CITY OF NAPOLEON - BUILDING DEPARTMENT
255 West Riverview Avenue, Napoleon, Ohio 43545 - 419-592-4010

Permit No. 705-77 Issued 4/26/77
Job Location 365 N. Harmony Dr.
Lot 41 Harmony Acres
Issued By Ronald D. Sonnenberg
Owner Don Westhoven 592-6481
Address 303 E. Clinton St.
Agent Blue Ridge Homes 385-4196
Address 4325 Holly Hill Toledo, Ohio
Description of Use New, single family dwelling
Residential XX(1)
Commercial _____ Industrial _____
New XX Add'n. _____ Alter _____ Remodel _____
Mixed Occupancy _____
Change of Occupancy _____
Estimated Cost \$40,000.00

RESIDENTIAL PLAN CORRECTION SHEET

ADDENDUM to Permit No. 705-77
 Owner D. WESTHOVEN
 Location 365 NORTH HARMONY DR.

SKETCH SHOWING
THREE APPROVED METHODS
OF DISCONNECTING DOWNSPOUTS
FROM SANITARY SEWERS. ALSO,
APPROVED METHOD OF HANDLING
STORM AND SURFACE WATER IN
NEW CONSTRUCTION.

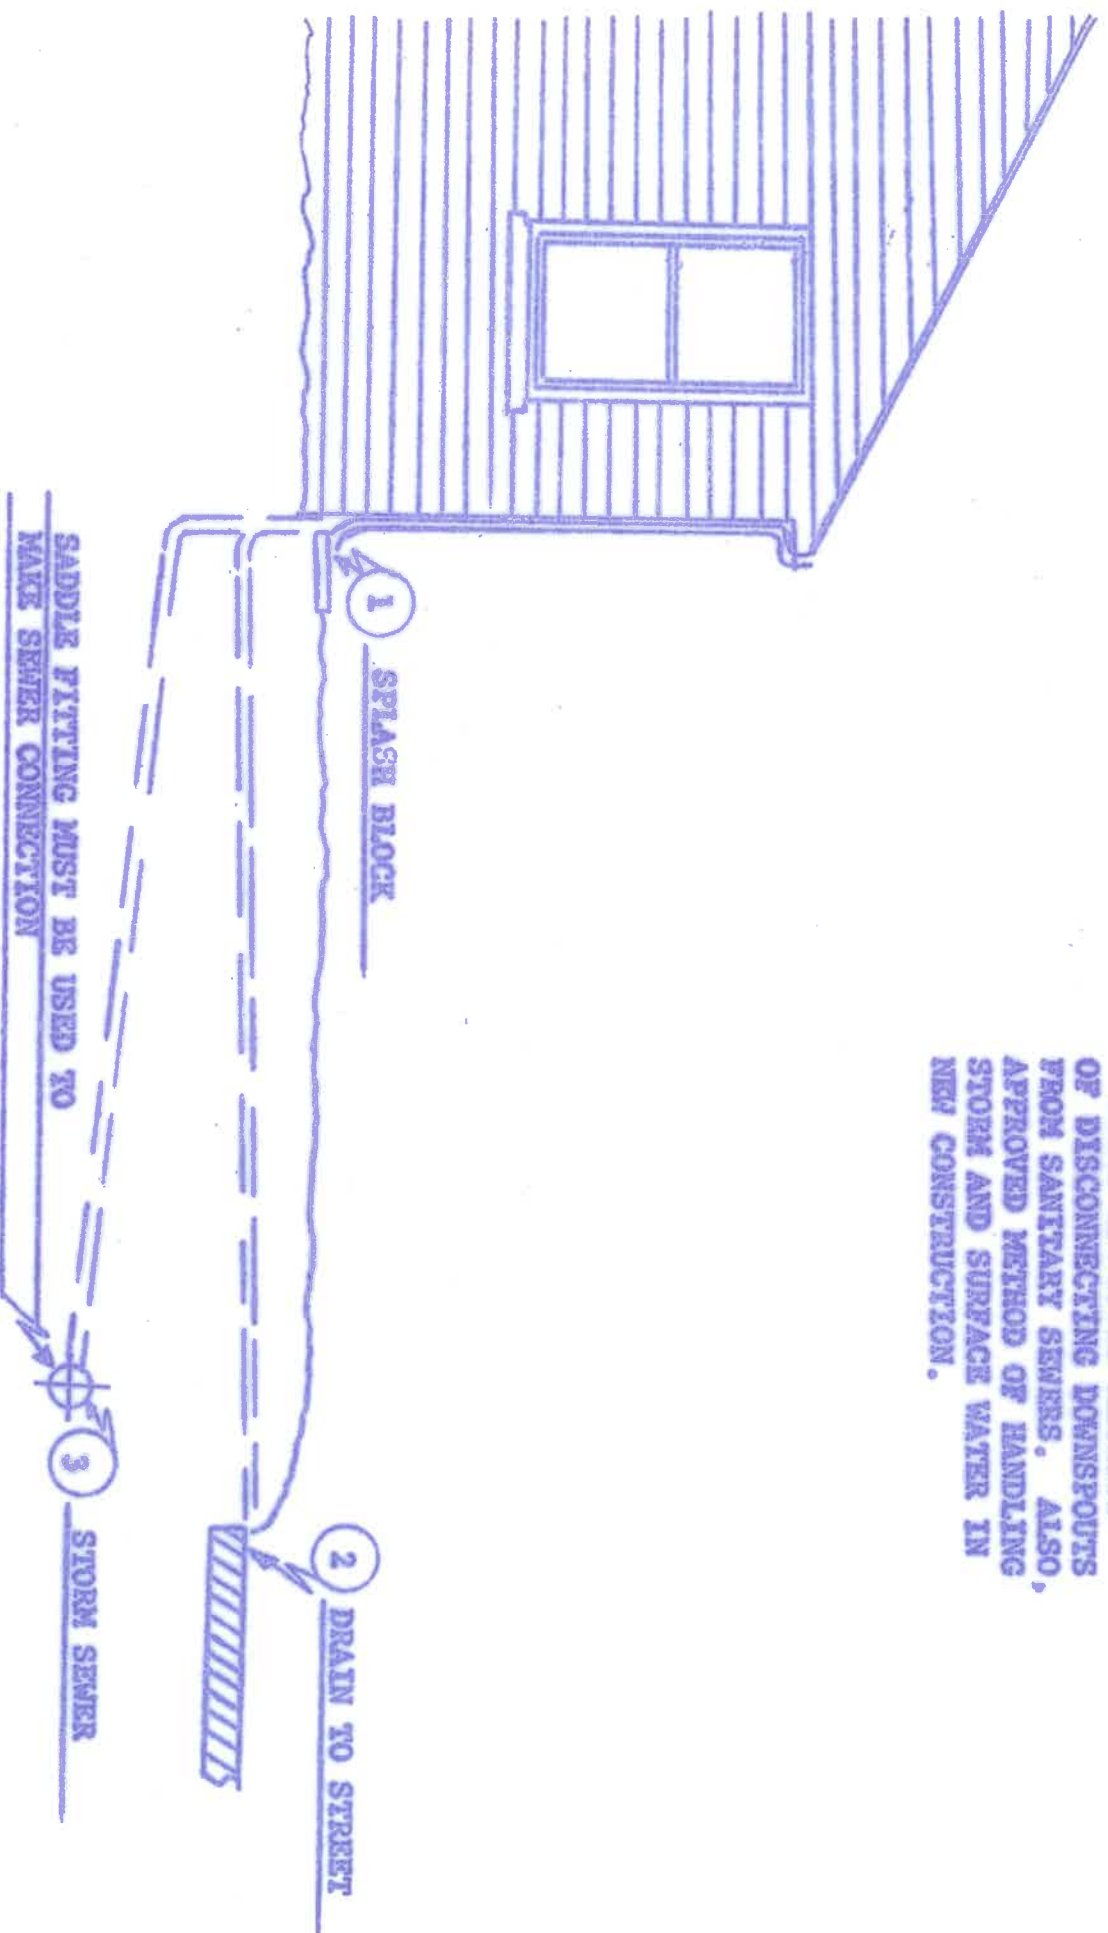
Substantial qualifications of occupancy Install one of the approved methods for handling storm water as shown on the attached sketch.
